# **DRAINAGE LETTER REPORT**

## **CRAWFORD APARTMENTS TRACT A, FOUNTAIN VALLEY RANCH FILING NO. 6B**

JPS Project No. 122102  
PCD File No. PPR-22-\_\_\_

**CRAWFORD APARTMENTS  
COMPOSITE RUNOFF COEFFICIENTS**

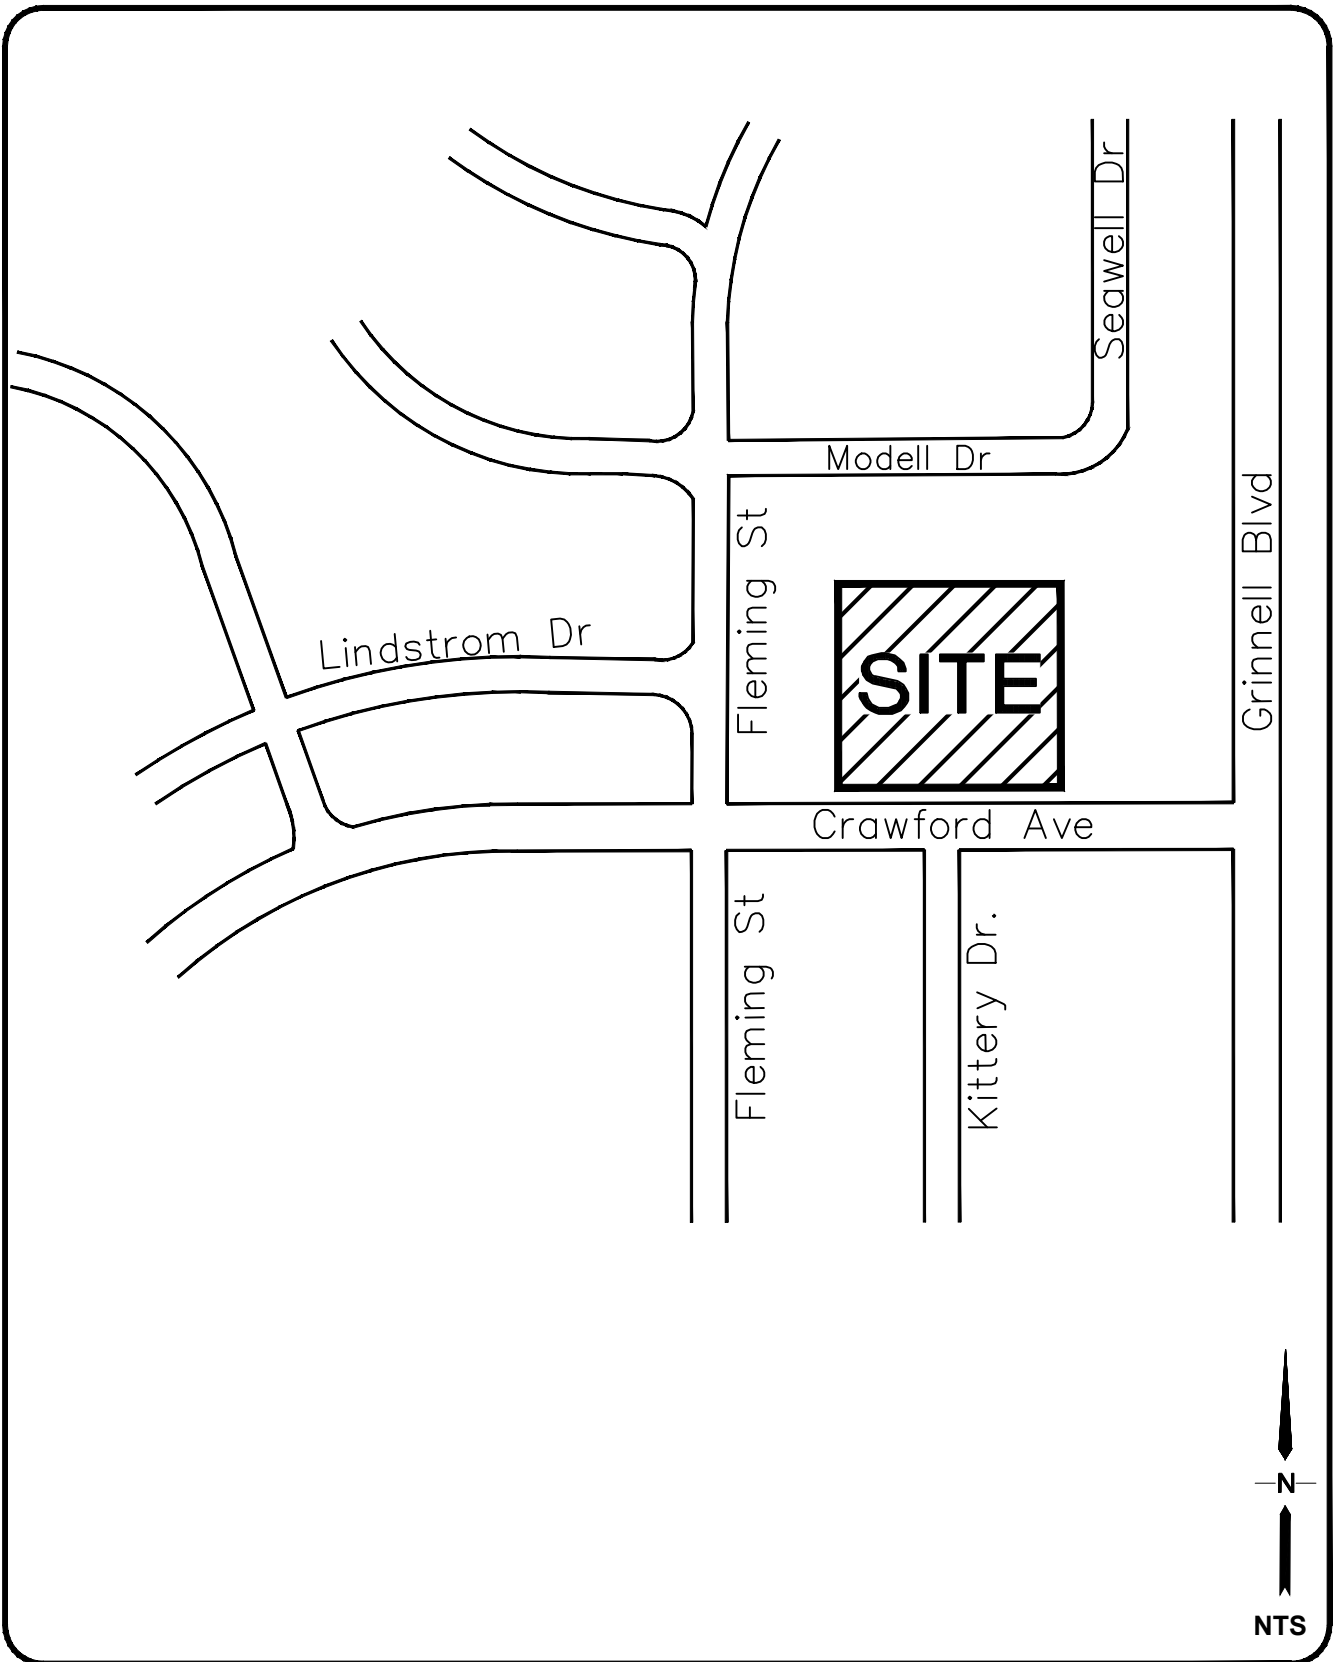
Per City DCM Runoff Coefficient Values in table 6-6 commercial coefficient are .81 and .88. Explain whether this value came from a calculation of what is there currently or revise to meet table values.

**DEVELOPED  
DRAINAGE PLAN**

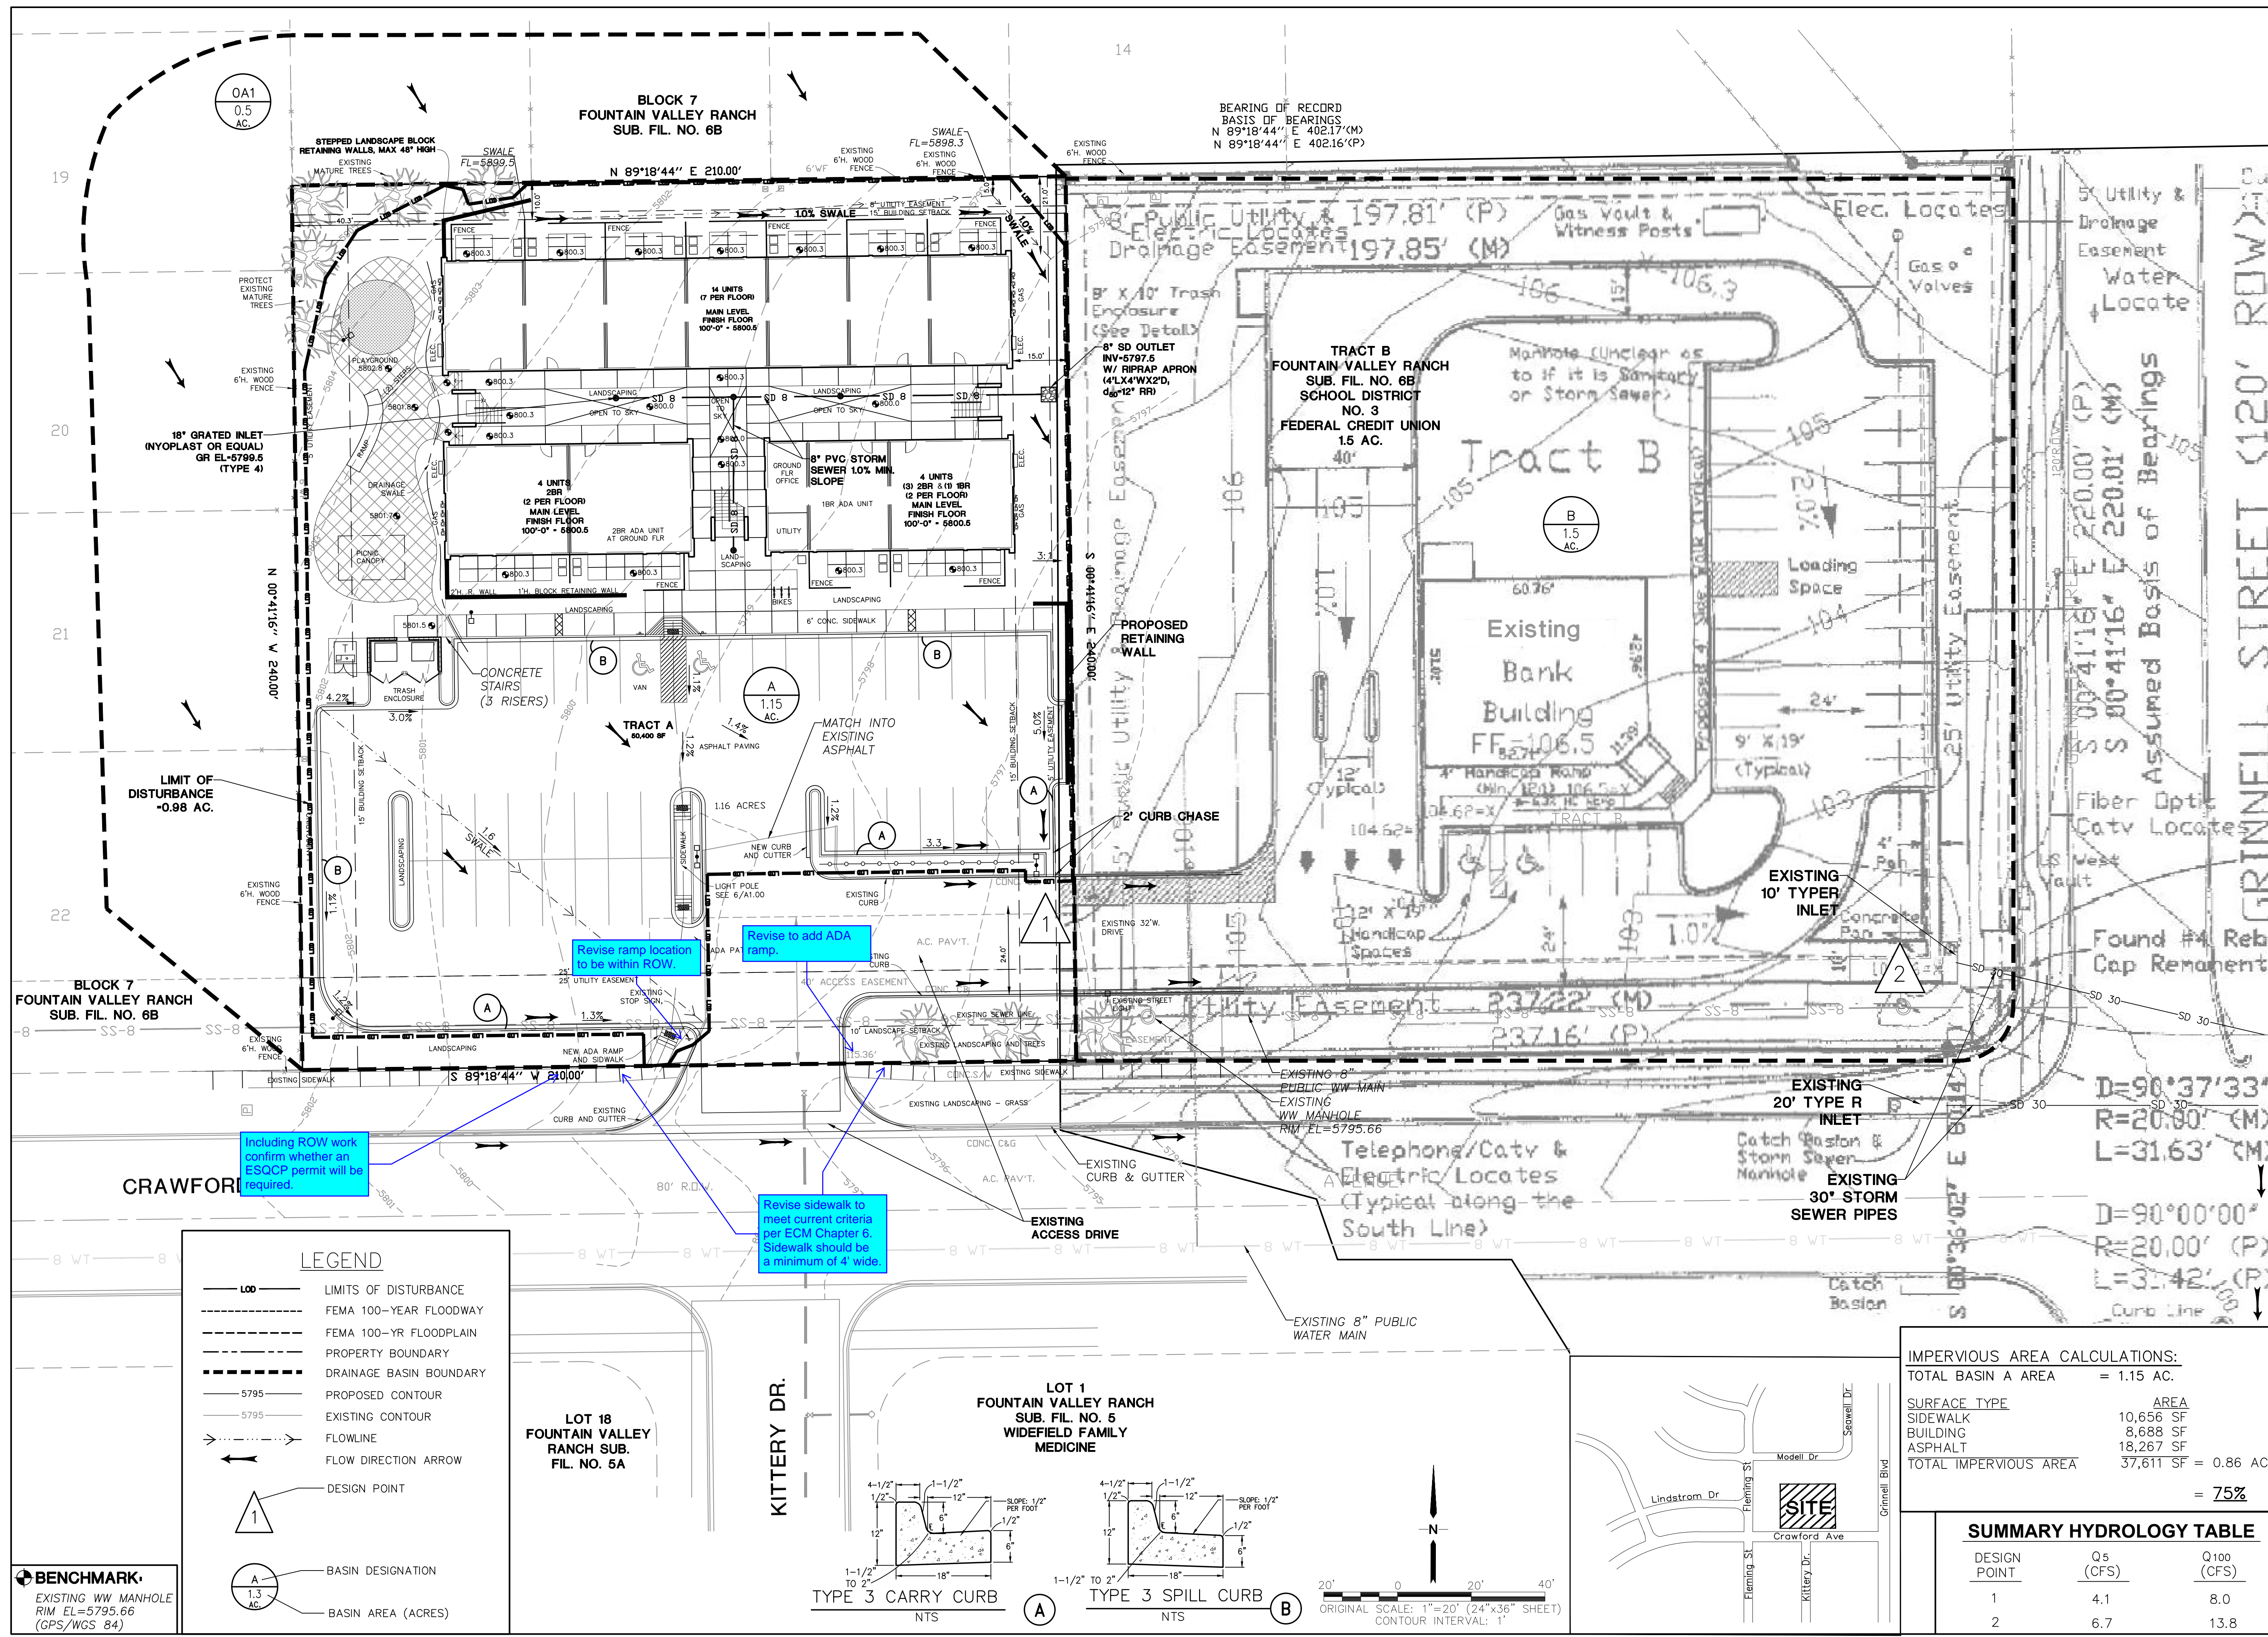
Revise ramp location to be within ROW.

Revise to add ADA ramp.

Including ROW work confirm whether an ESQCP permit will be required.

Revise sidewalk to meet current criteria per ECM Chapter 6. Sidewalk should be a minimum of 4' wide.
